PRELIMINARY FOUNDATION REPORT

OSUNA TRAIL BRIDGE AT SAN DIEGUITO RIVER OSUNA SEGMENT OF COAST TO CREST TRAIL PROJECT SAN DIEGO, CALIFORNIA

Subject: **GEOTECHNICAL MEMORANDUM – RESPONSE TO CITY COMMENTS**
City of San Diego Project Issues Report PRJ-1049410
Osuna Trail Segment and Pedestrian Bridge
San Dieguito River Park, San Diego County

PRELIMINARY GEOLOGIC/GEOTECHNICAL MAP- SITE PLAN

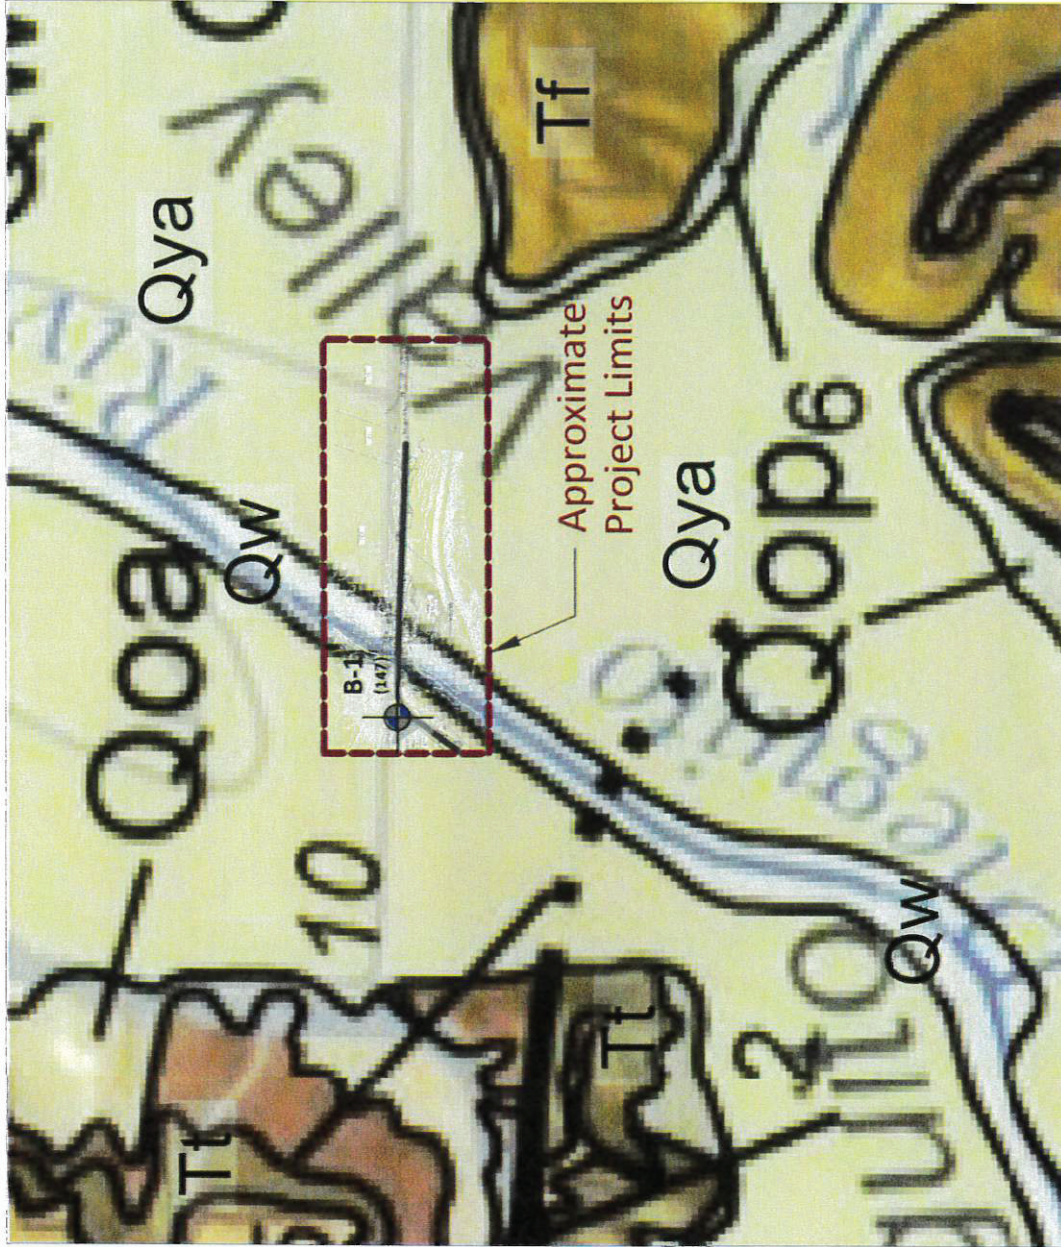
Comment 00006:

shows the proposed development; the overall site plan or preliminary grading plan could provide a suitable base map.

Response: Figure 1A attached presents a preliminary geologic/geotechnical map showing the mapped regional geology, the location of a nearby geotechnical boring by others, and the project's proposed development by overlaying the current overall site plan. Figure 1B attached present a preliminary geologic/geotechnical map showing the estimated existing distribution of fill and geologic units, the location of the referenced geotechnical report's exploratory boring by others, and the project's proposed development using a portion of the preliminary grading plan as a base map.

1A

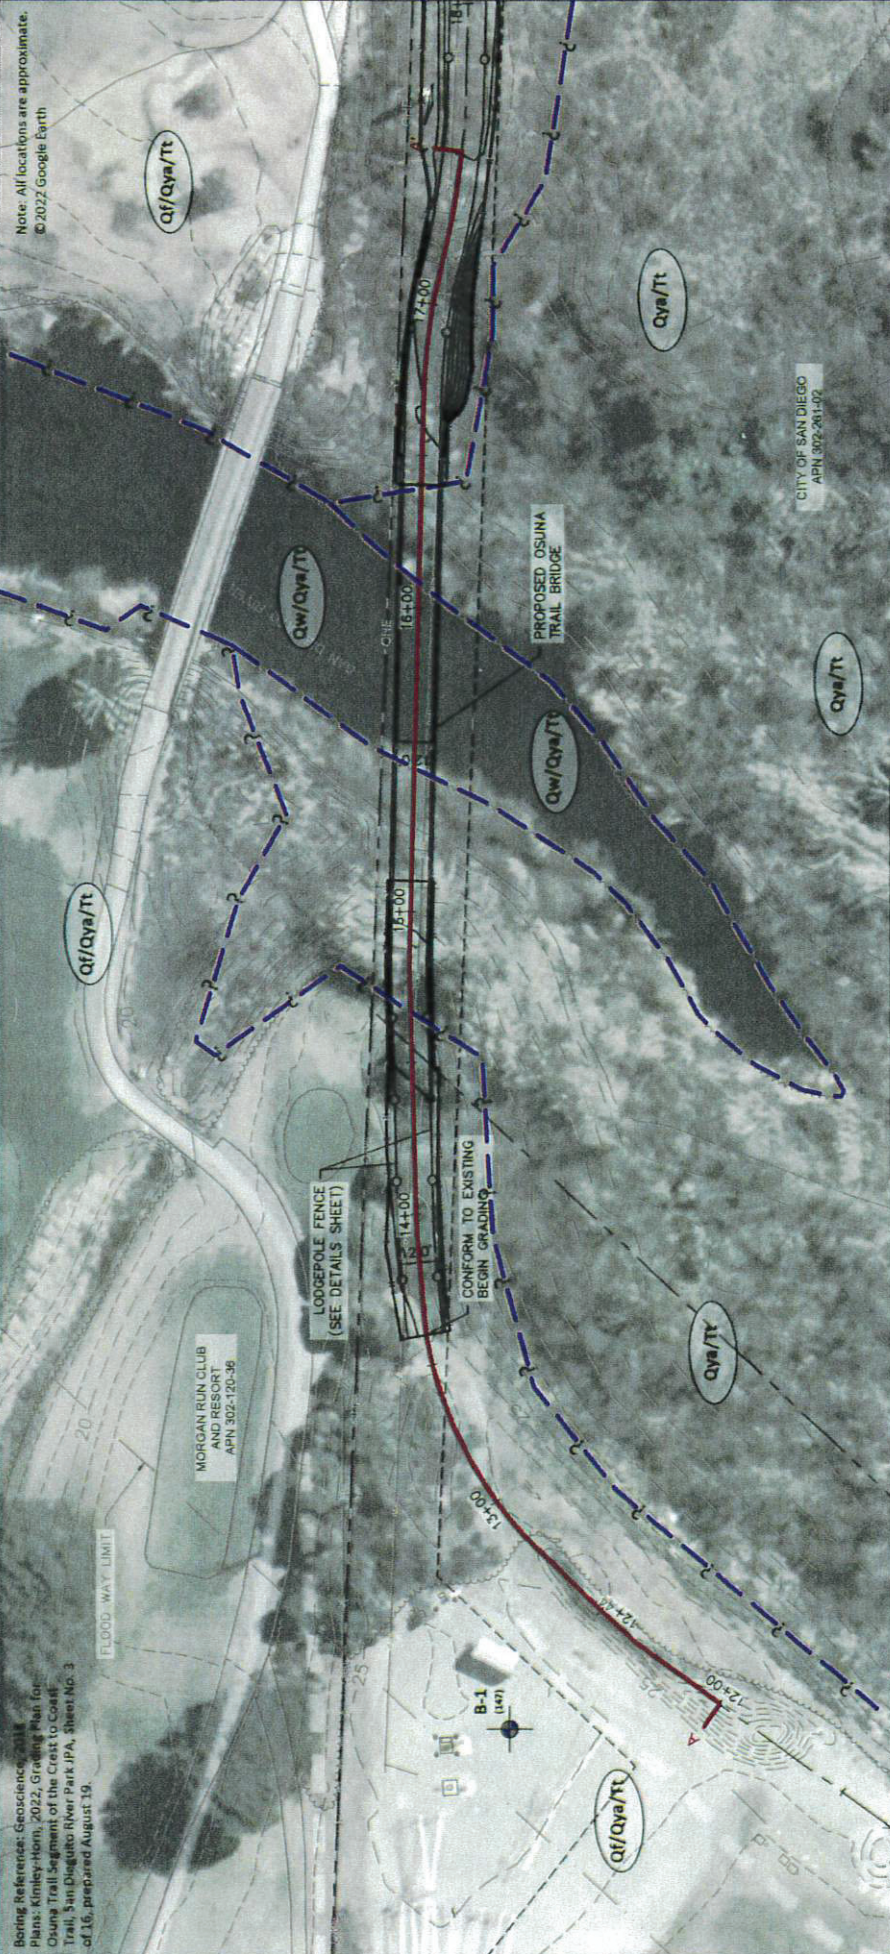
Comment 00007: *Circumscribe the limits of anticipated remedial grading on the geologic/geotechnical map to delineate the proposed footprint of the project.*

Response: Figure 1B, attached, present a geologic/geotechnical map delineating the estimated anticipated remedial grading based on the current proposed footprint of the project.

PRELIMINARY GEOLOGIC/GEO TECHNICAL MAP- SITE PLAN
Osuna Trail Segment and Pedestrian Bridge
San Dieguito River Park, San Diego County

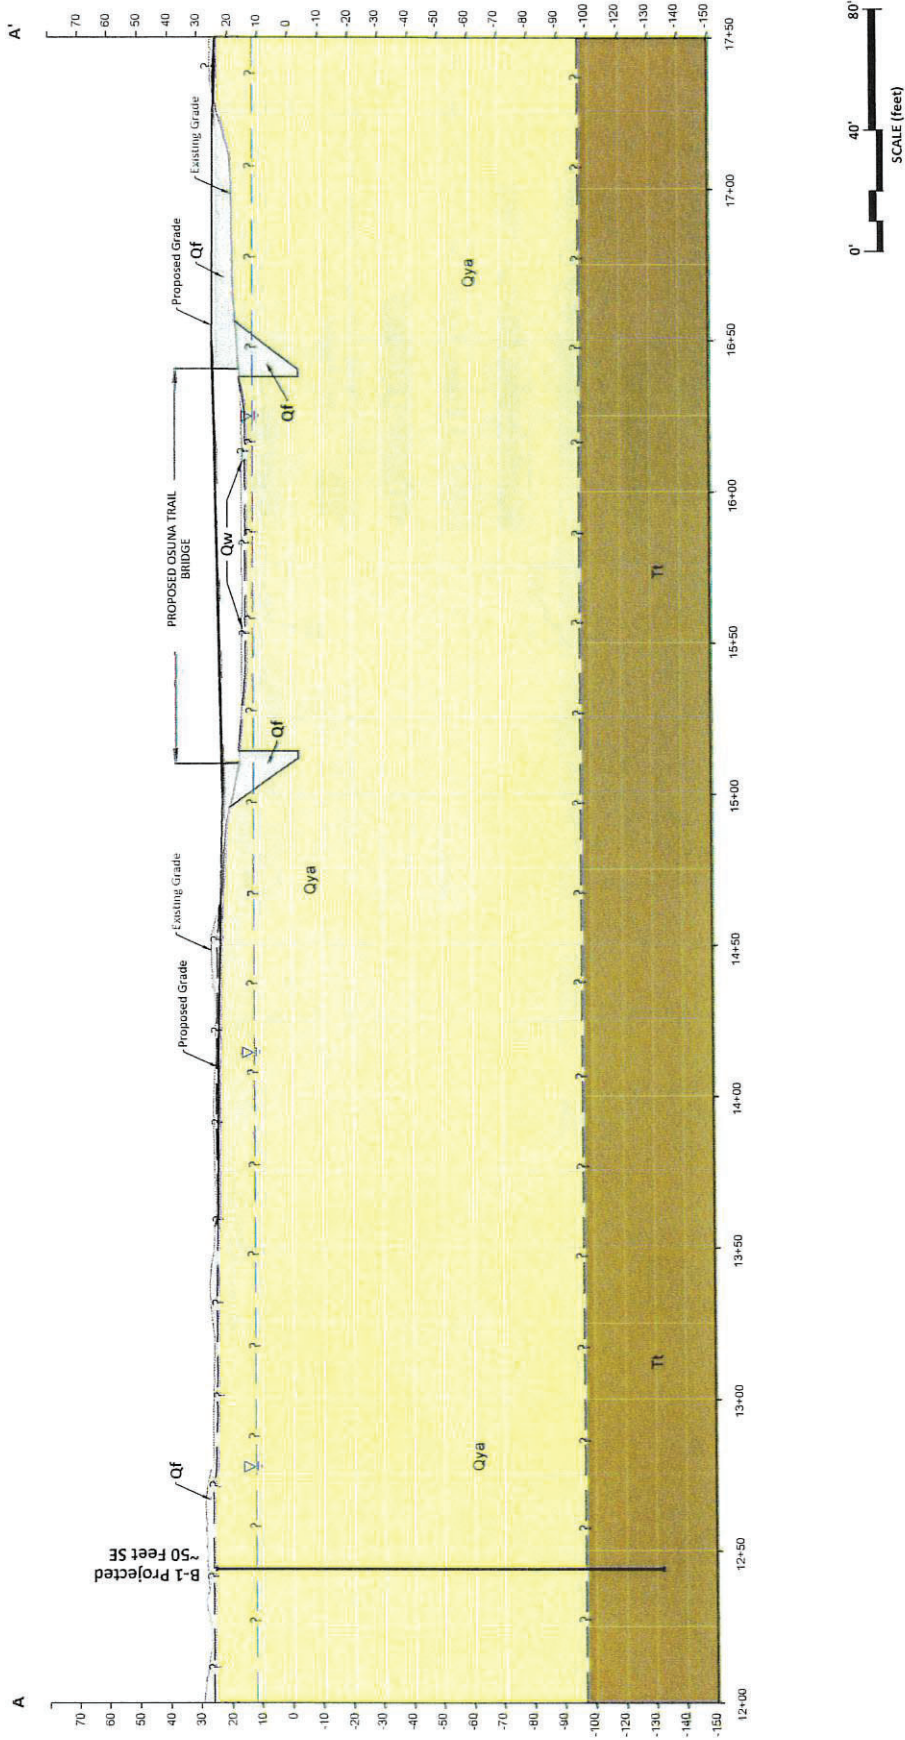
Comment 00008: *The geotechnical investigation report must contain representative geologic/geotechnical cross-sections that show the existing and proposed grades, distribution of fill and geologic units, groundwater conditions, and the proposed development.*

Response: Figure 2, attached, presents a preliminary geologic cross-section at the pedestrian bridge, based on the referenced boring, showing the existing and proposed grades, estimated distribution of fill and geologic units, groundwater conditions, and the proposed development.

Based on the preliminary scour analysis performed (Kimley-Horn, 2020), a 10-year flood event is estimated to scour soils to depth of about 13.7-feet, and so the foundations are anticipated to be at a depth of about 14 to 20 feet to mitigate scour. Figure 2 presents the conservative approximate anticipated depth of grading based on the preliminary scour analysis and the proposed development. These estimates are subject to change based on actual subsurface data at the bridge abutments.

3

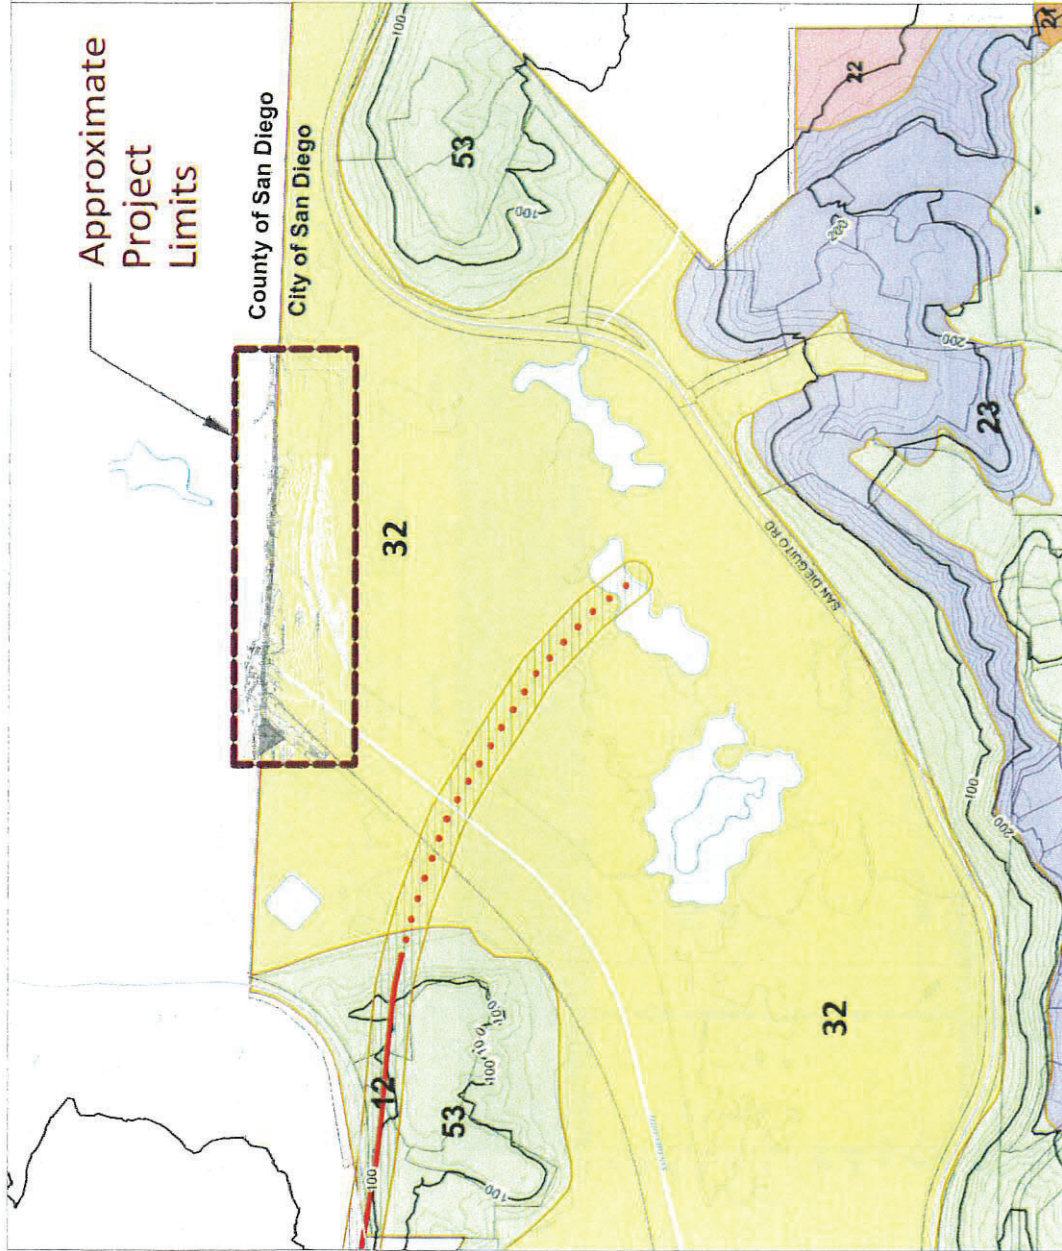
Comment 00010: *The geotechnical consultant must indicate if the site is suitable for the proposed development as designed or provide recommendations to mitigate any possible geologic hazards to an acceptable level.*

Figure 3 attached presents the site on the City of San Diego Seismic Safety Study Map. The site is located in Category 32, a liquefaction zone described as “Low Potential for Liquefaction with fluctuating groundwater and minor drainage” (City of San Diego, 2008). However, the project’s geotechnical report indicates that liquefaction-induced settlement of the ground surface is expected on the order of 30 inches. Although liquefaction can be mitigated with ground improvement and/or deep foundations, the extent of those mitigation methods would be great and are expected to be cost prohibitive, as well as more disturbing to the natural environment. Both the significant depth of the bridge abutments foundations and the remedial grading anticipated at the abutments is expected to mitigate the liquefaction-induced settlement, however it is assumed the bridge design will accommodate the settlement to an acceptable level of risk.
